Burke Gilman Trail Missing Link

Meeting Summary

This was the Seattle Design Commission's (SDC) second review of the Burke-Gilman Trail Missing Link project since 2014. The purpose of this meeting was to review the schematic design phase of the project. After the presentation, questions, and deliberation, the SDC voted, 7-0, to approve the schematic design phase of the Burke-Gilman Trail Missing Link project with several recommendations.

Figure 2: Proposed improvements at Market St and 28th Ave (left) and Market St and 24th Ave (right) intersections

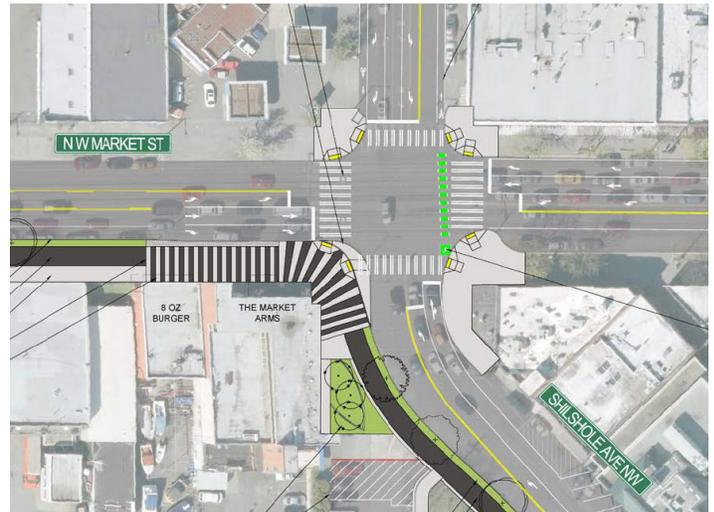
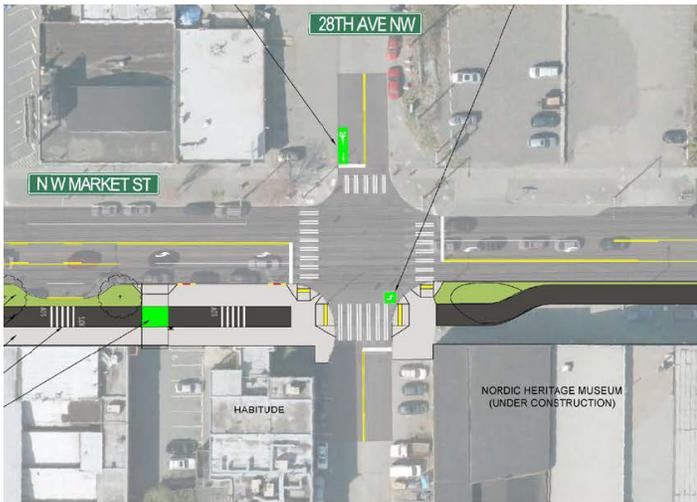
The SDC agreed the proposed design is well integrated with the surrounding urban network. Commissioners commended the project team for providing connections to the water and neighborhood greenways. Commissioners also appreciated how the trail interacts with areas along NW Market St. The commission recognized the difficulty in designing a pathway that will be used as a sidewalk and trail. Commissioners commended the project team for providing an adequate solution for separating different uses.
